## *City of El Paso – City Plan Commission Staff Report*

**Case No:** SUSU15-00084 Charter School Solutions  
**Application Type:** Resubdivision Combination  
**CPC Hearing Date:** February 11, 2016  
**Staff Planner:** Armida Martinez, (915) 212-1605, [martinezar@elpasotexas.gov](mailto:martinezar@elpasotexas.gov)  
**Location:** North of Betel and West of Americas  
**Acreage:** 10.667  
**Rep District:** 6  
**Existing Use:** Vacant  
**Existing Zoning:** A-2 (Apartments)  
**Proposed Zoning:** A-2 (Apartments)  
**Nearest Park:** Feather Lake (.58 miles)  
**Nearest School:** Harmony Science Academy (K-12) Charter (next door)  
**Park Fees Required:** N/A  
**Impact Fee Area:** N/A  
**Property Owner:** Charter School Solutions  
**Applicant:** Charter School Solutions  
**Representative:** Etzold & Co

### ATTACHMENT 3

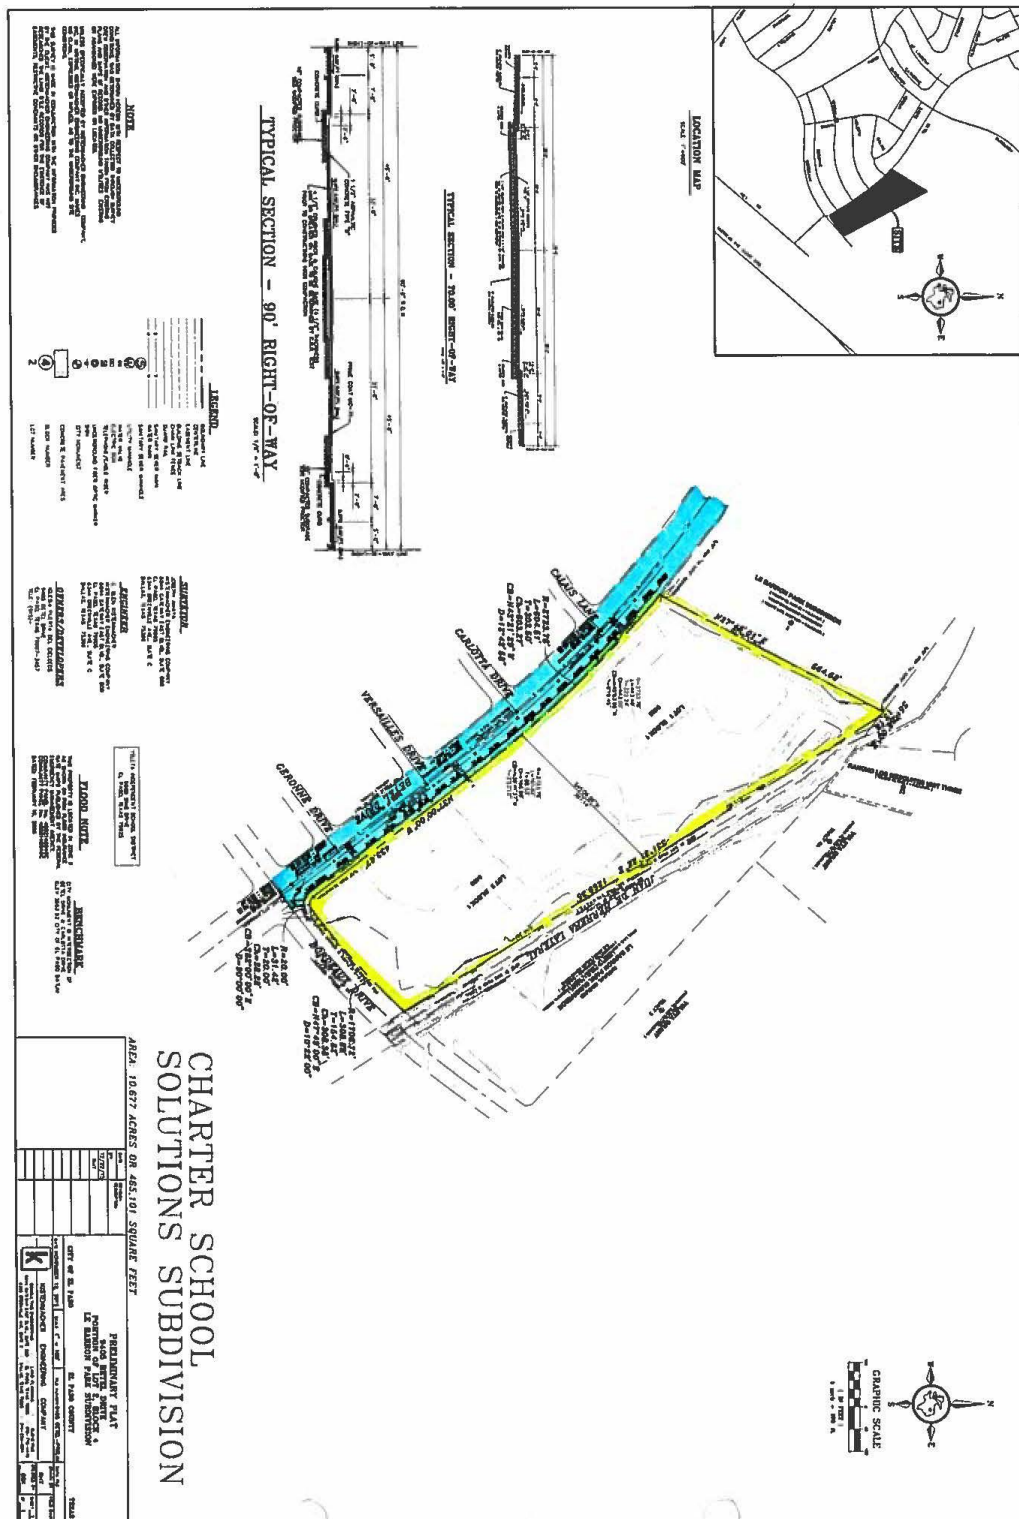
1. Scale typical street cross section for 70' ROW to match the scale of the 90' ROW for legibility on preliminary plat.
2. Remove the pavement thickness values on both typical cross sections.
3. Add note to final plat sheet: "The retention of the difference between Historic and Developed Storm-water runoff discharge volumes shall be retained within subdivision limits (DSC, 19.19.010A and DDM, 11.1). Historic storm water runoff rates must not be exceeded. Ensure historic runoff volume, peak, and duration are maintained.

3. Label Betel Drive cross-section as it is designated as a minor arterial. Per DSC requirements a 5ft. sidewalk is required on the applicant's proportionate share.

4. The proposed Bordeaux Drive cross section appears to be substandard. Bordeaux Drive is designated as a Non-Residential Collector and does not comply with DSC for a Non-Residential Collector. (5 ft. sidewalk is required).

12. Verify dedication statement.
13. Provide drainage arrows on the preliminary plat.

## ATTACHMENT 4

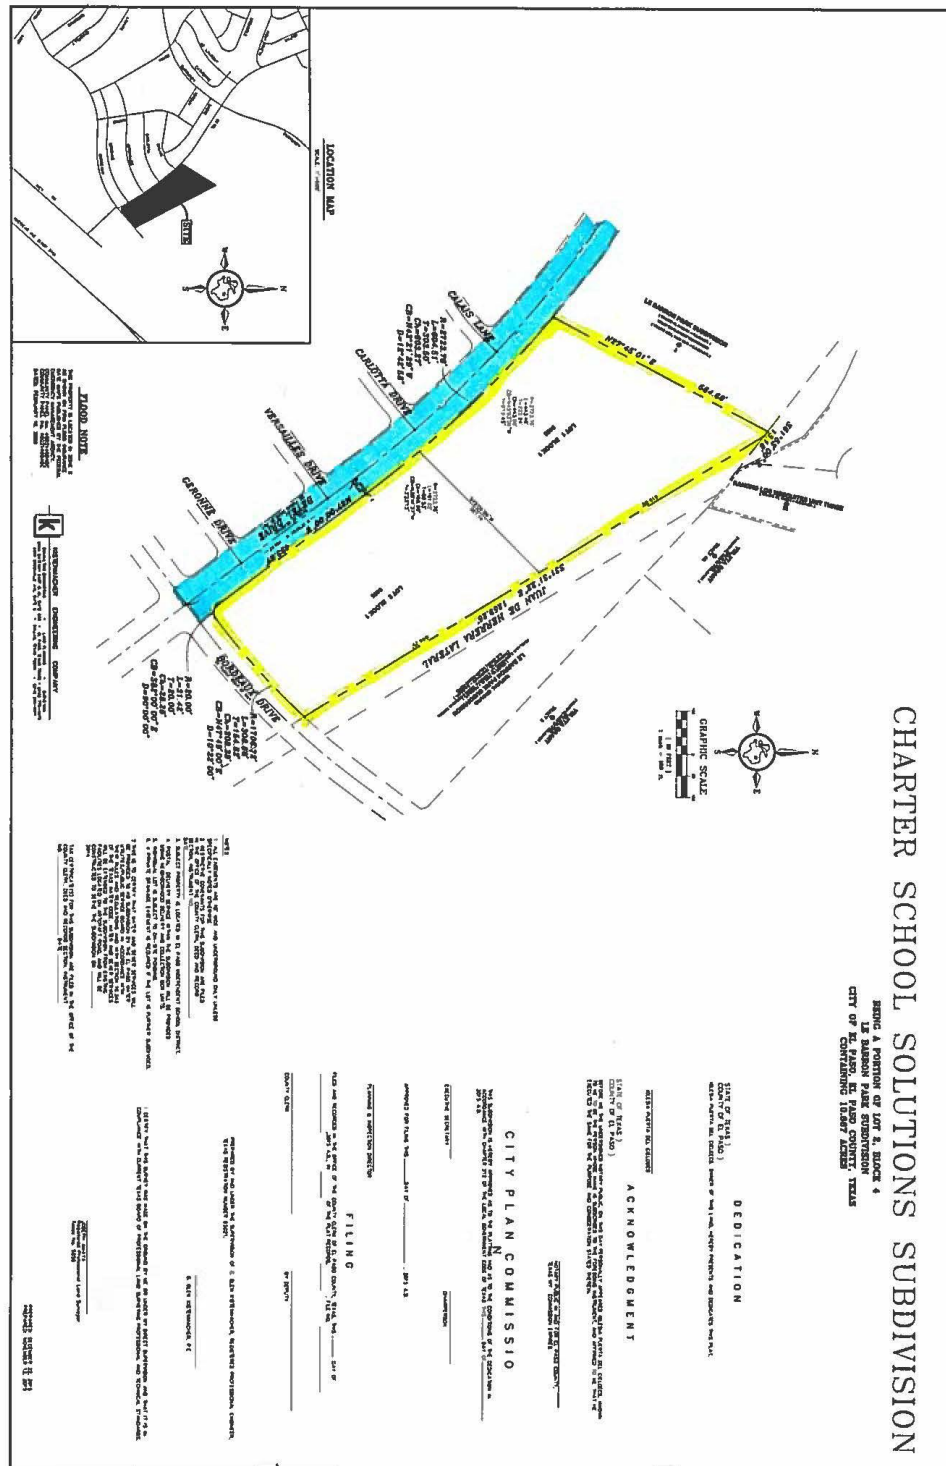
5. Provide reason for the replat.
6. Identify appropriate school district on final plat.
7. Verify statement 7 under "Notes" on the final plat.
8. Provide acreage and square footage of each lot.

9. Verify owner in the dedication statement.
10. Verify Lot boundary dimensions
11. Indicate if any proposed easements are being dedicated, as well as any existing easements.
